**Meridian Airport Authority, Dean Aircraft Services
Hangar Additions & Alterations**

ADDENDUM NO. 2

TO: All Bidders on the Above Referenced Product
FROM: Davis Purdy Architects, PLLC
DATE: March 12, 2020
SUBJECT: **ADDENDUM NO. 2**

Sheet Title
MILLWORK

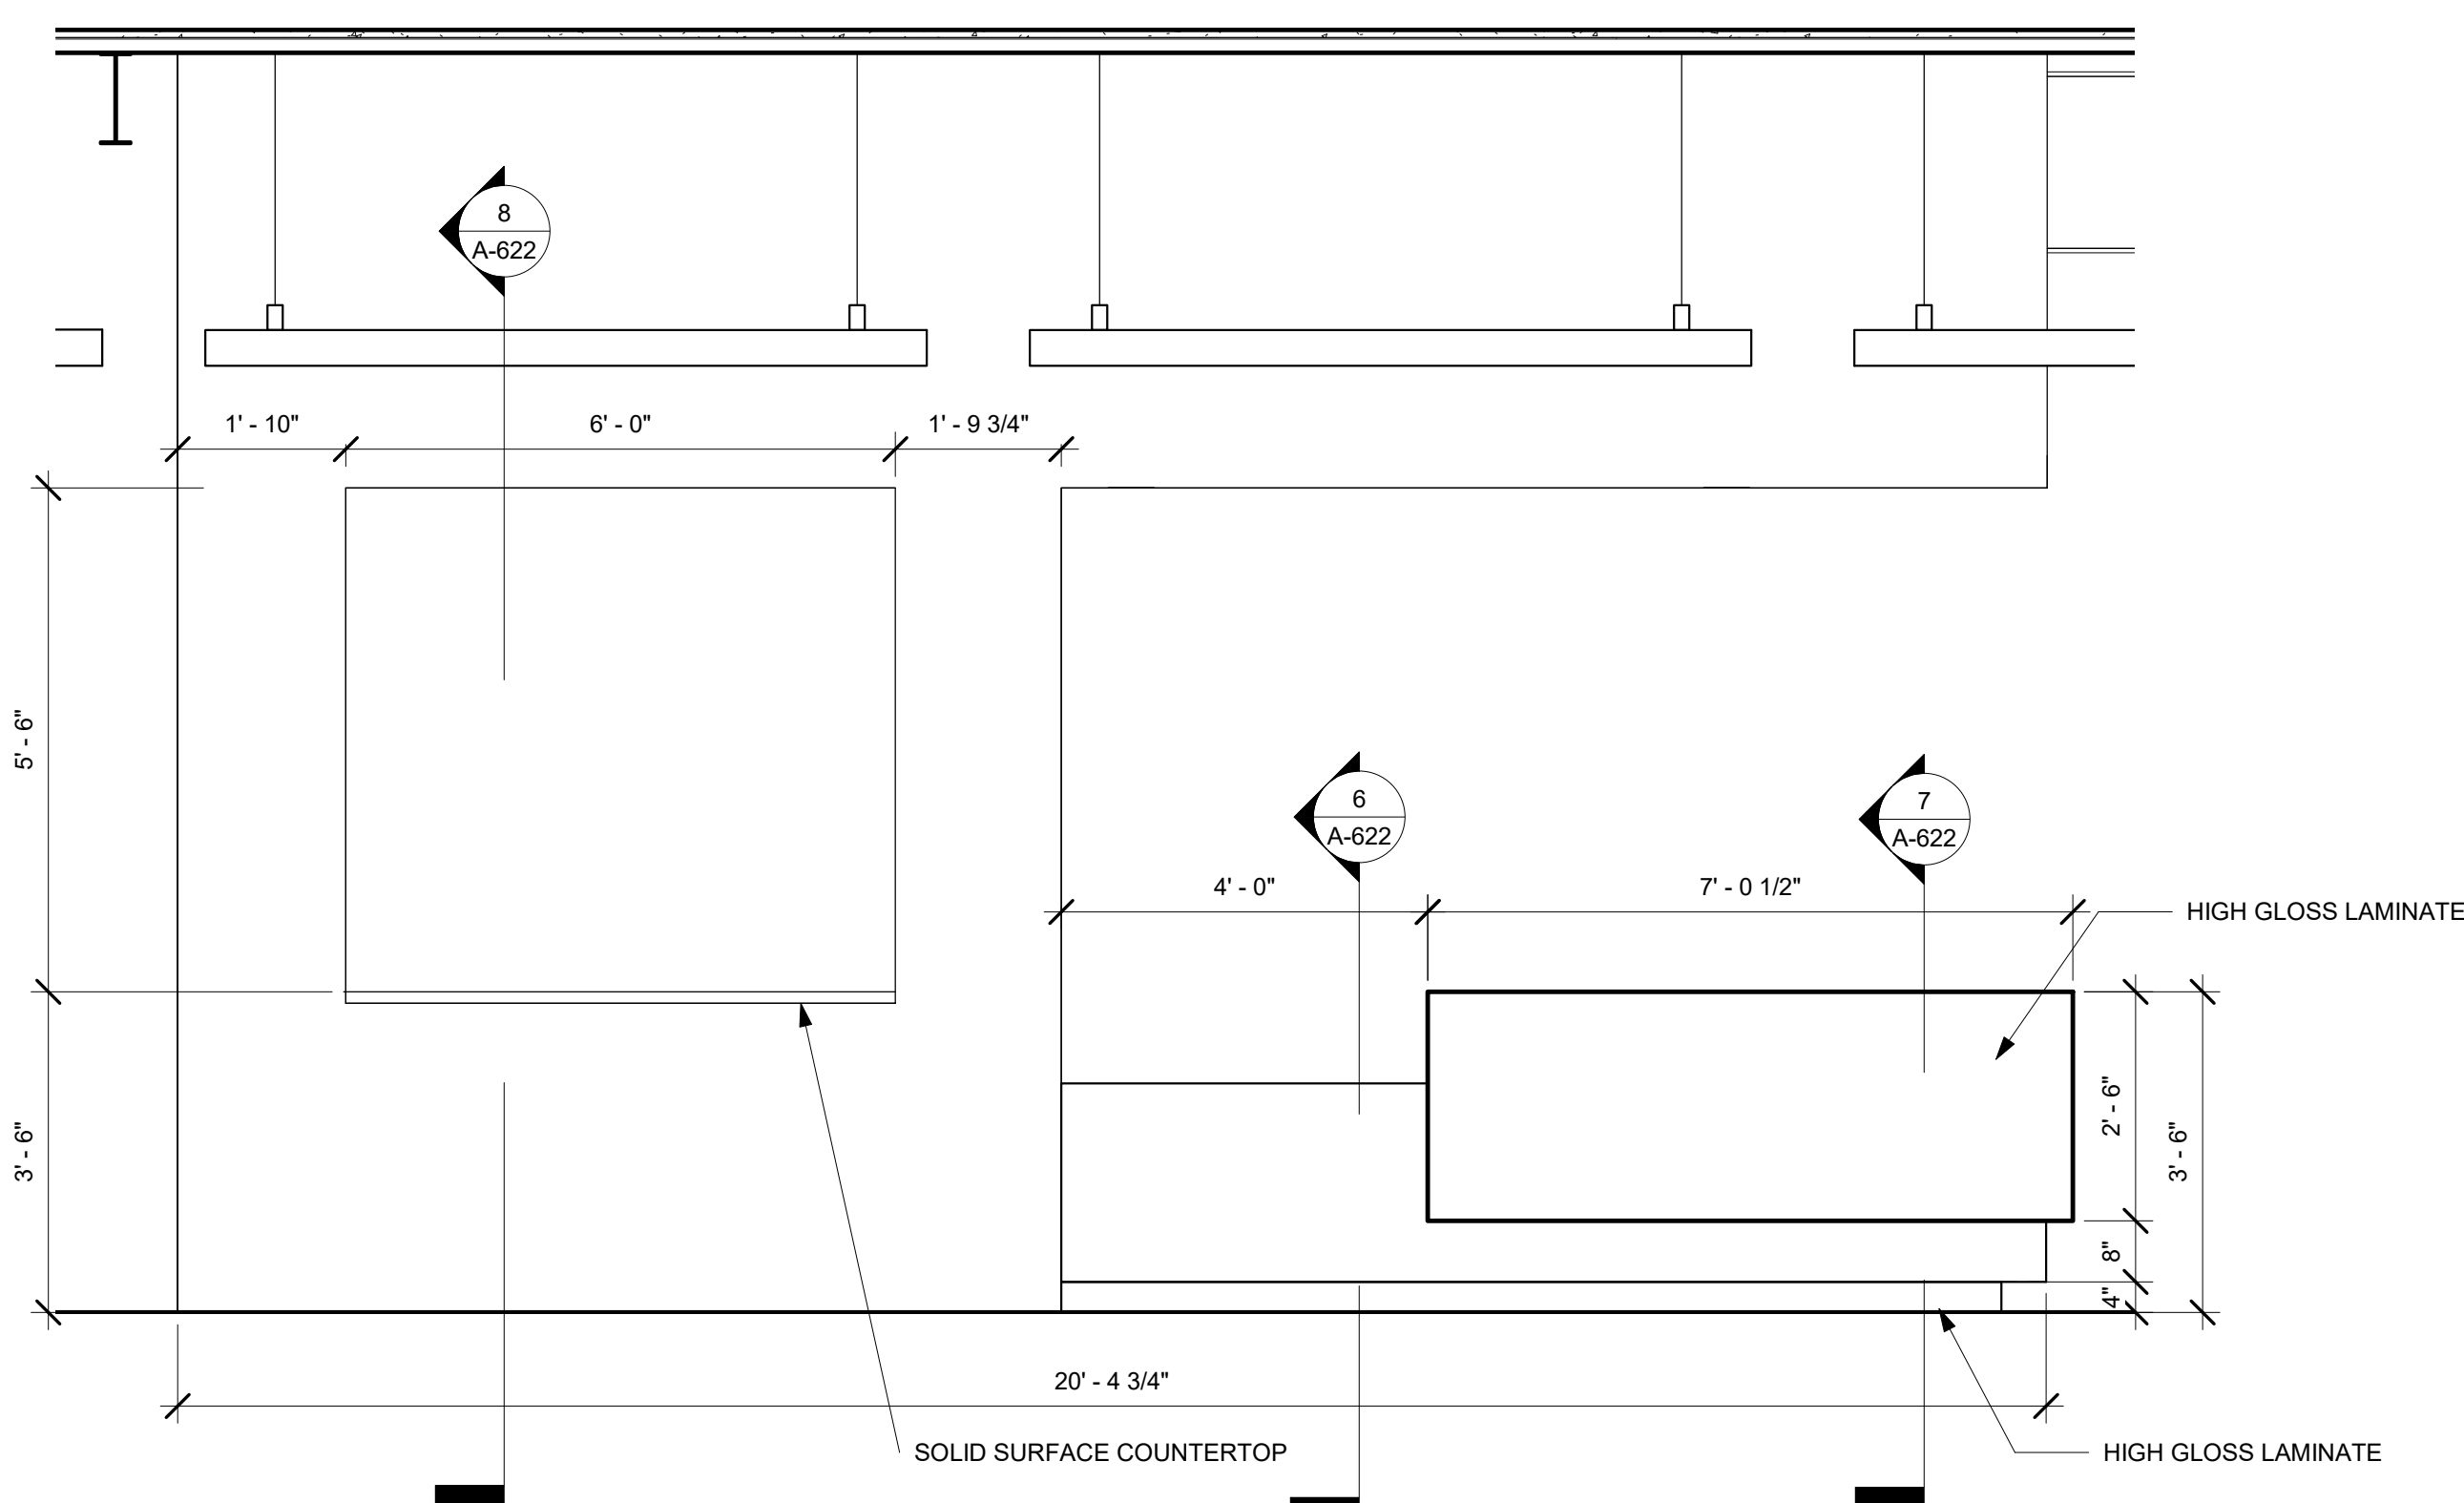
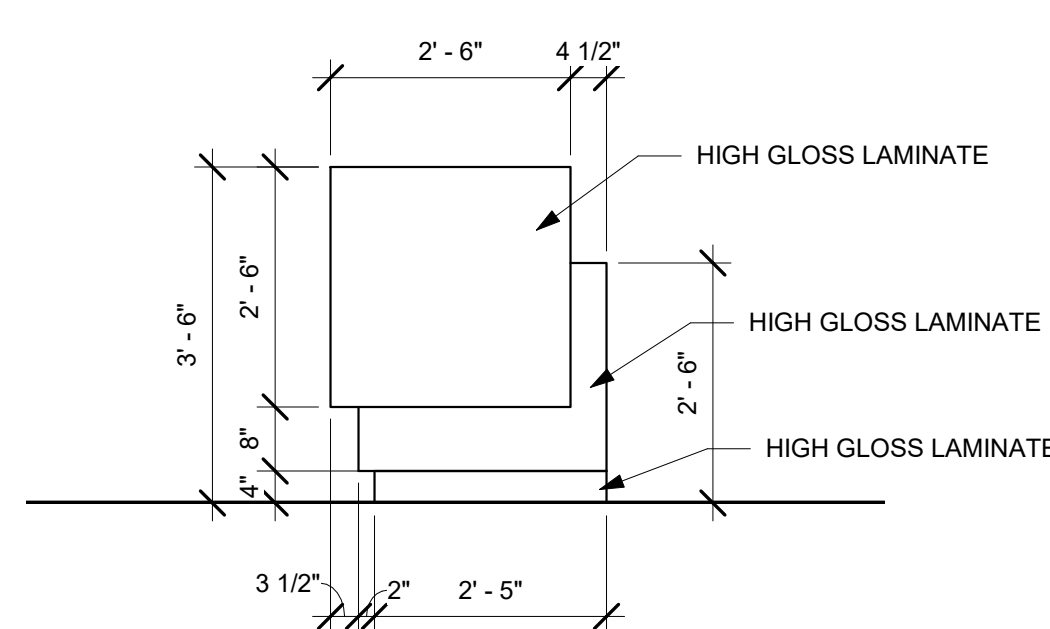
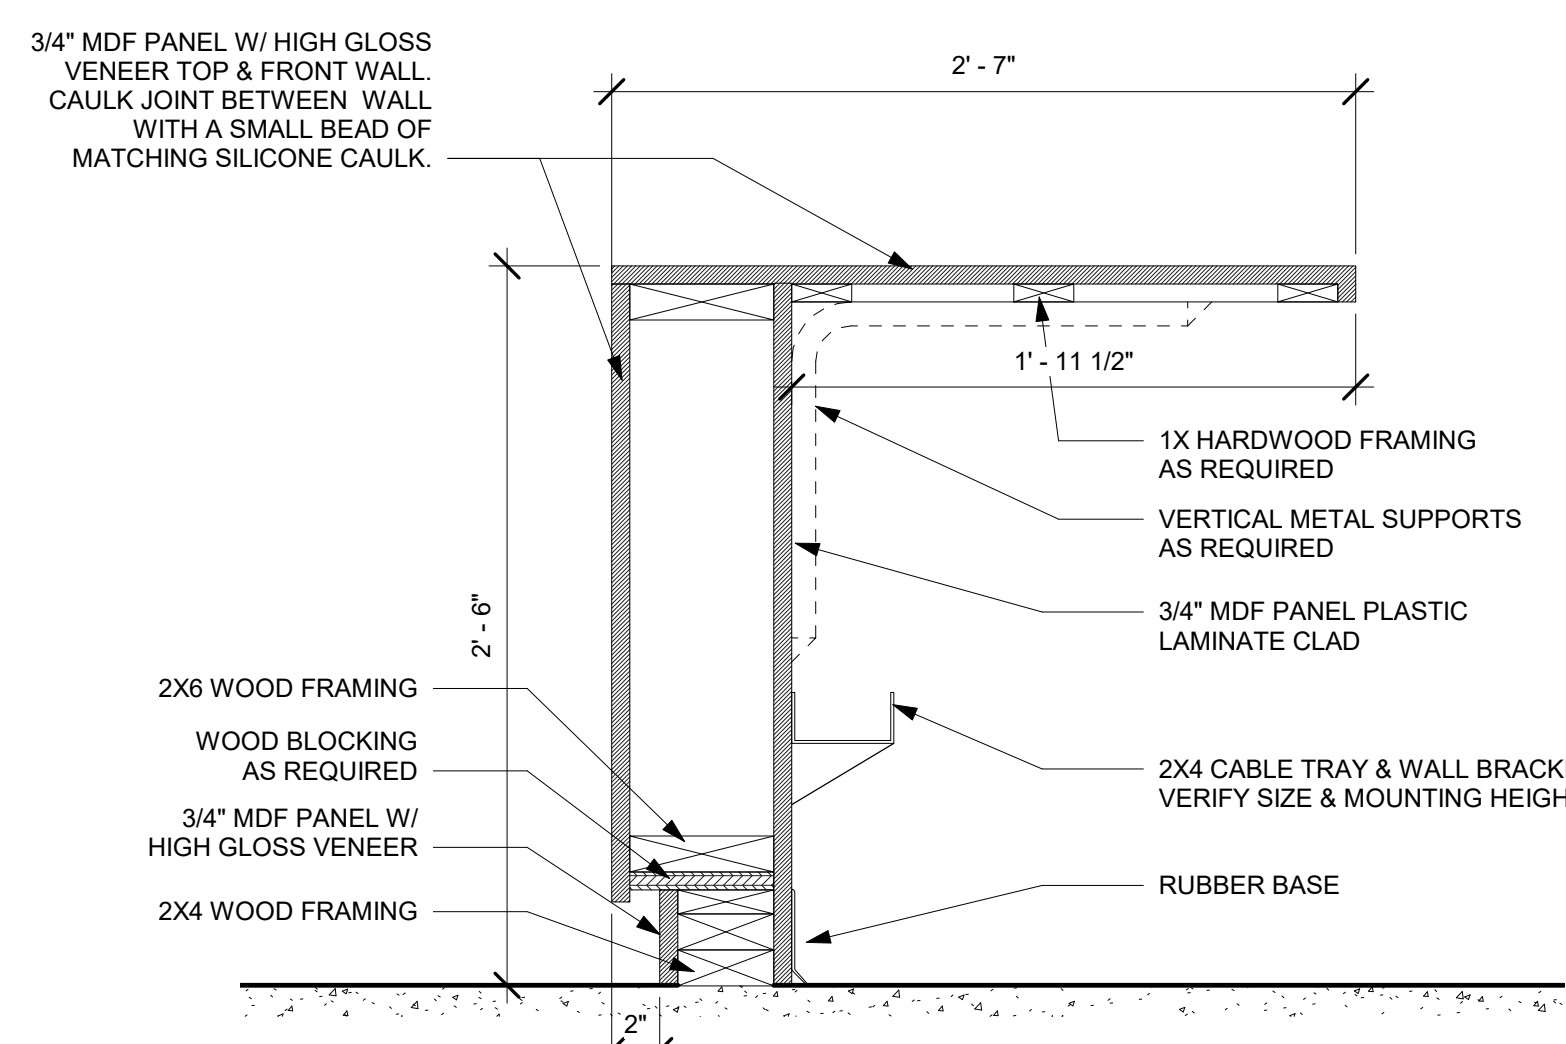
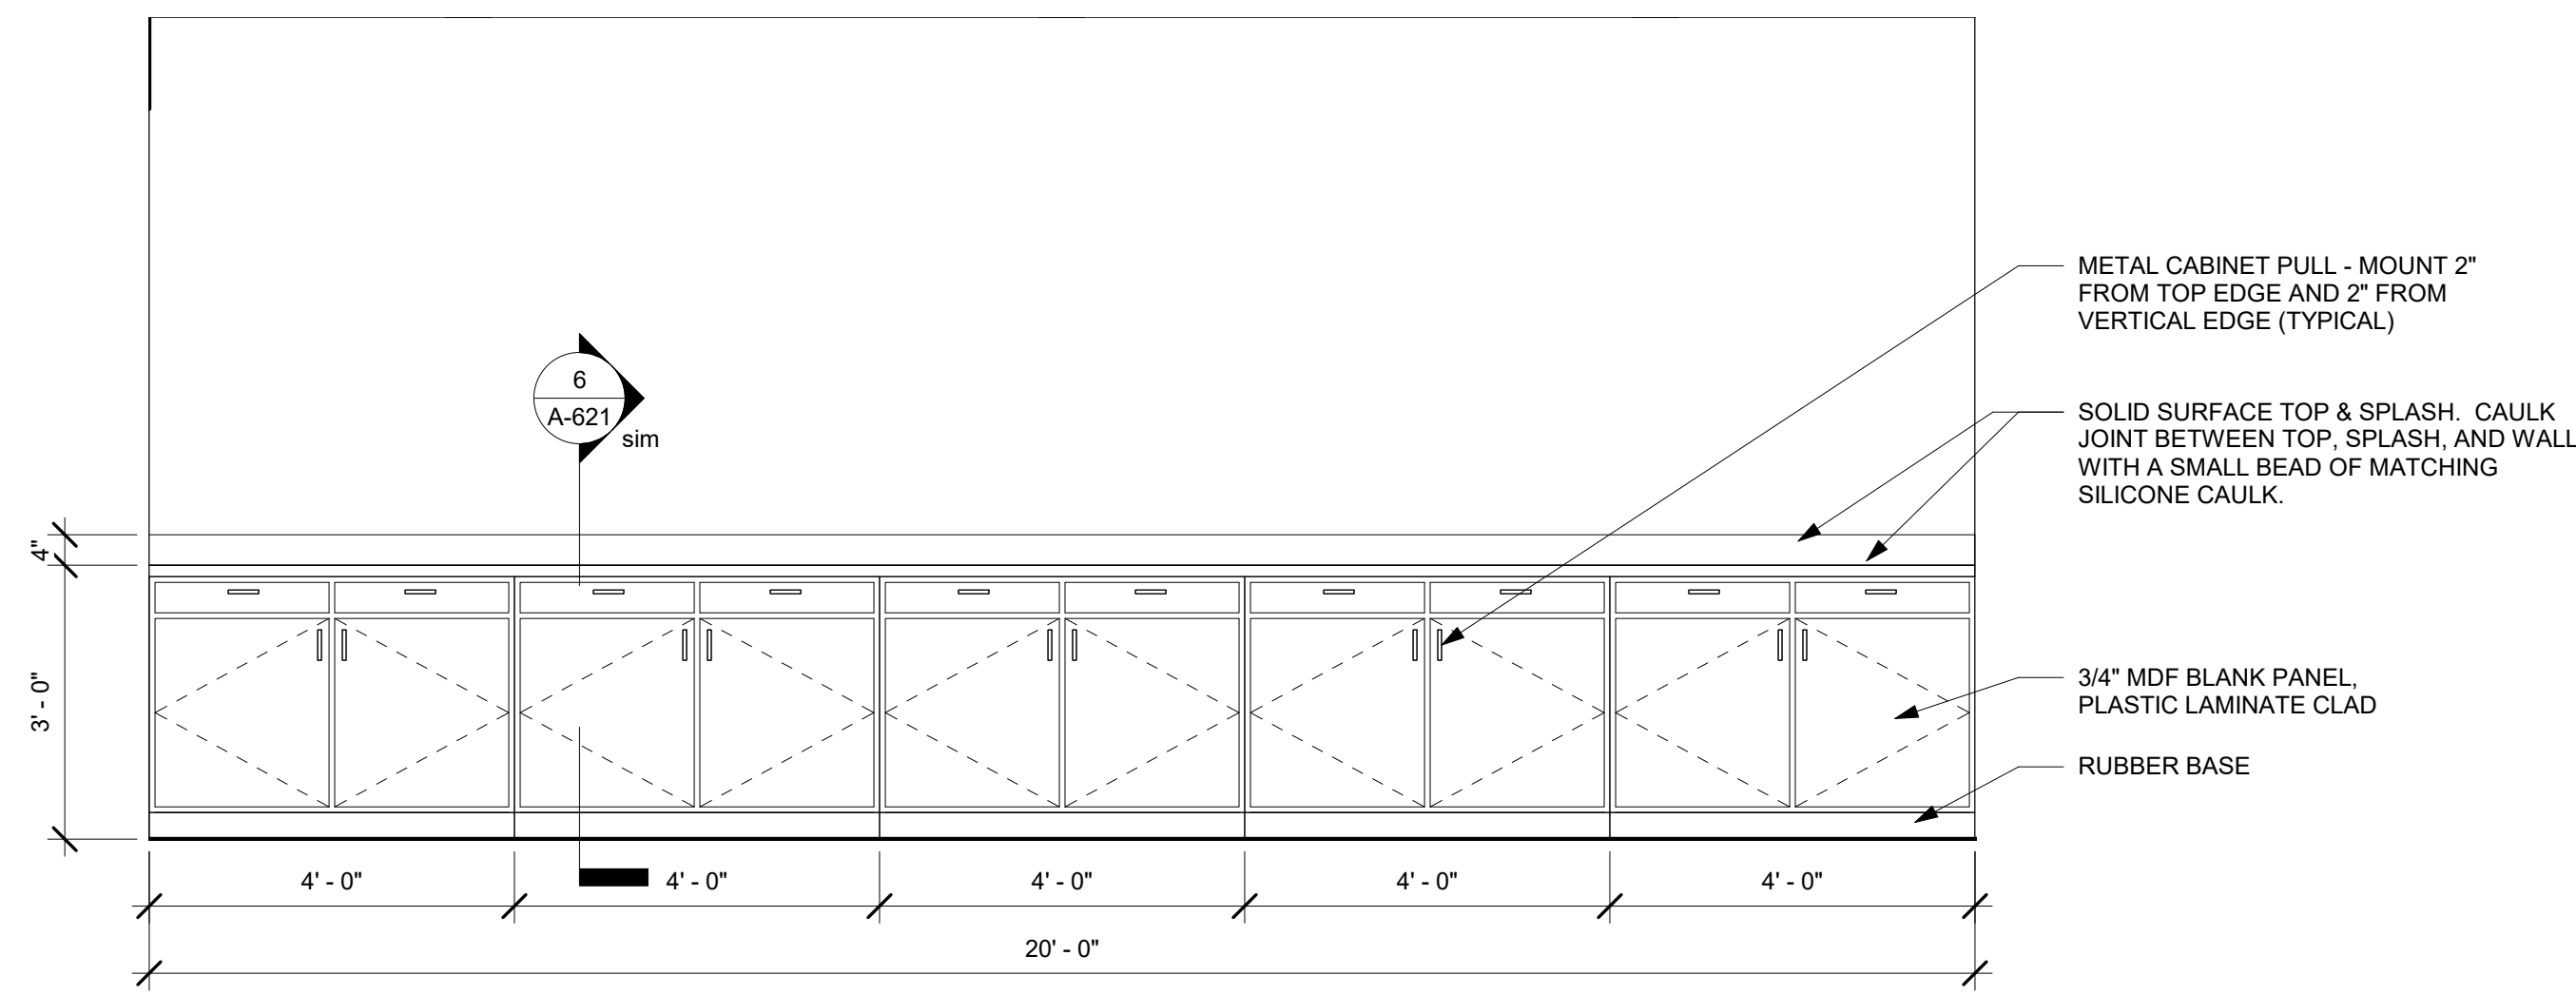
47. REPLACE: Replace the Architectural sheet A-622 MILLWORK dated 2/28/20 with Architectural sheet **A-622** dated 3/12/20. Sheet A-622 is attached.
